Amended Drawing 20-3-2022

Proposed Ground Floor Plan (1:50)

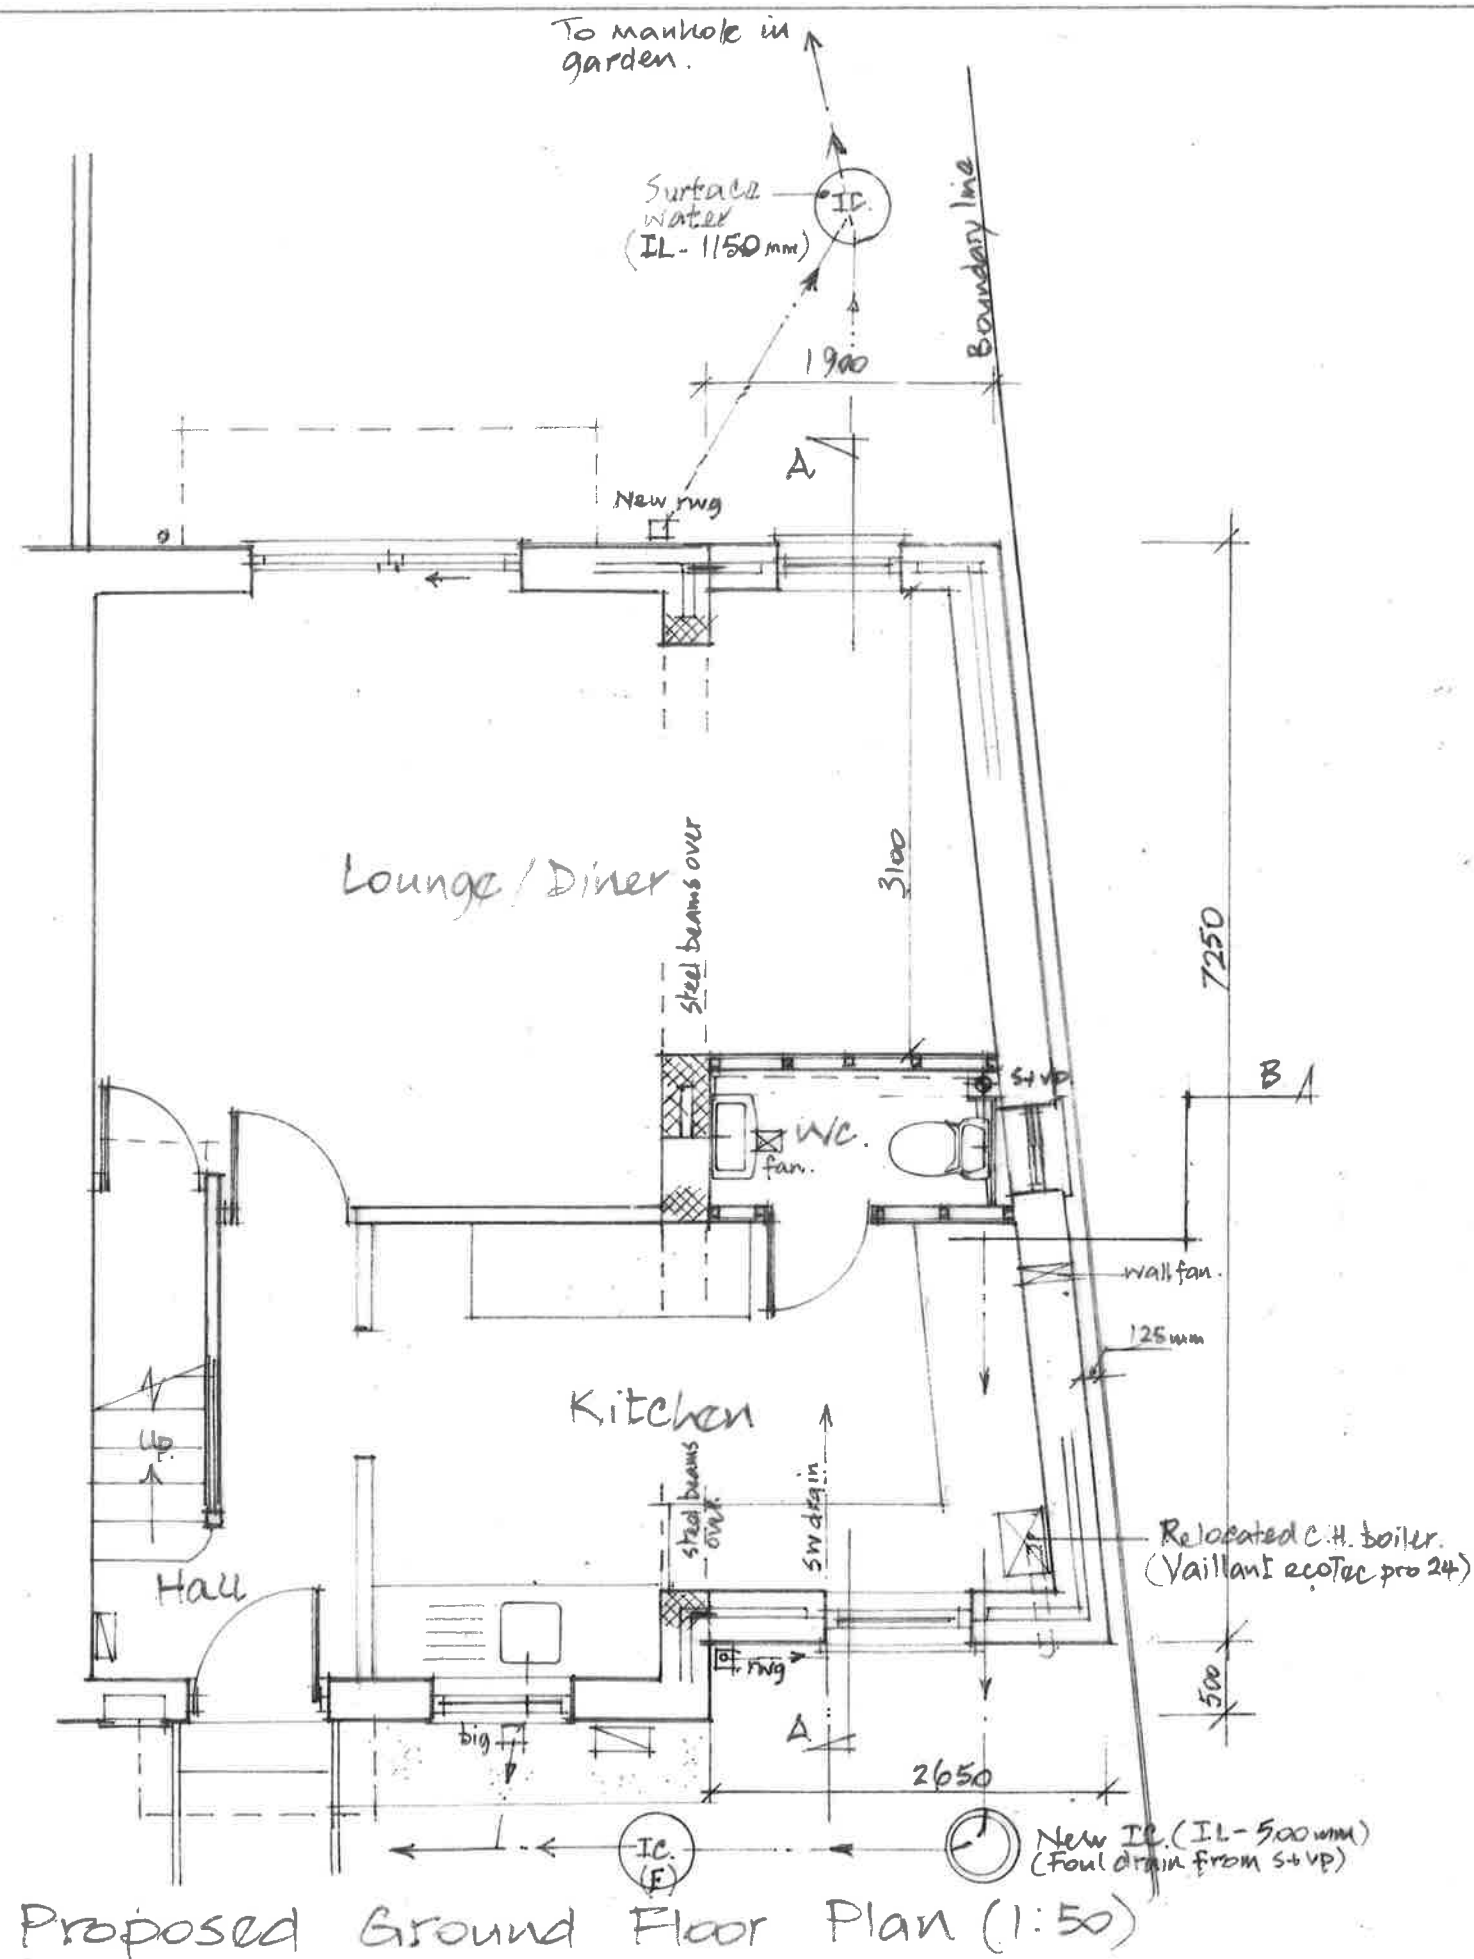
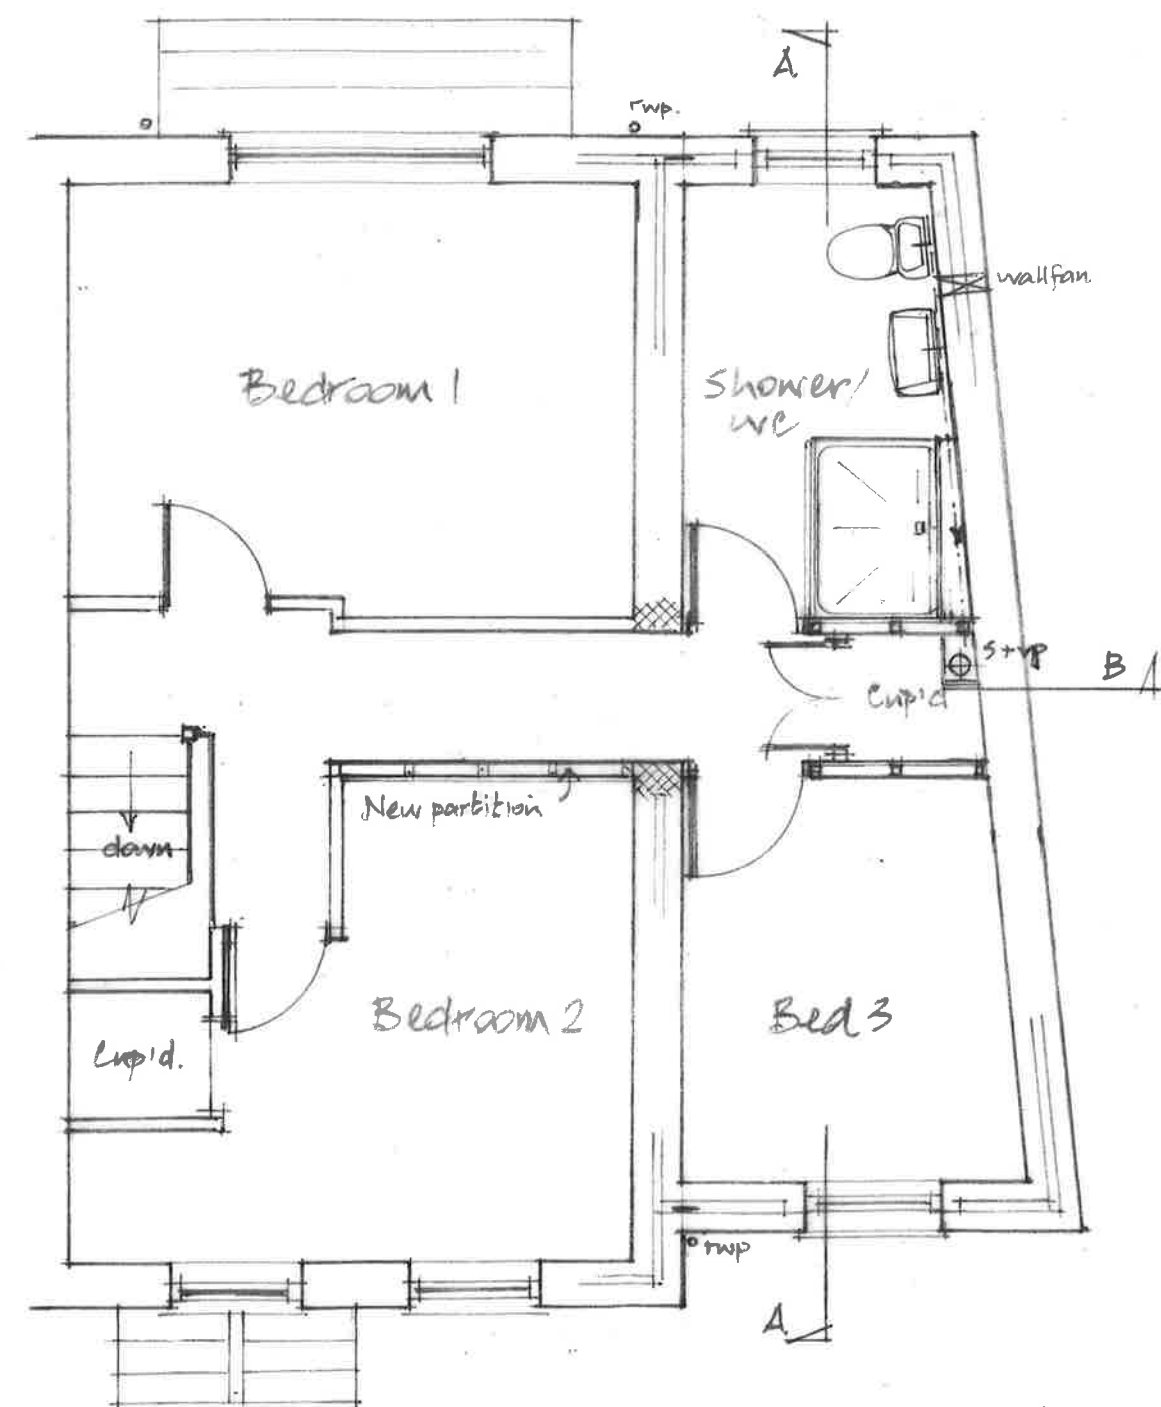
1. Drainage details added.
2. Soil & vent pipe relocated.
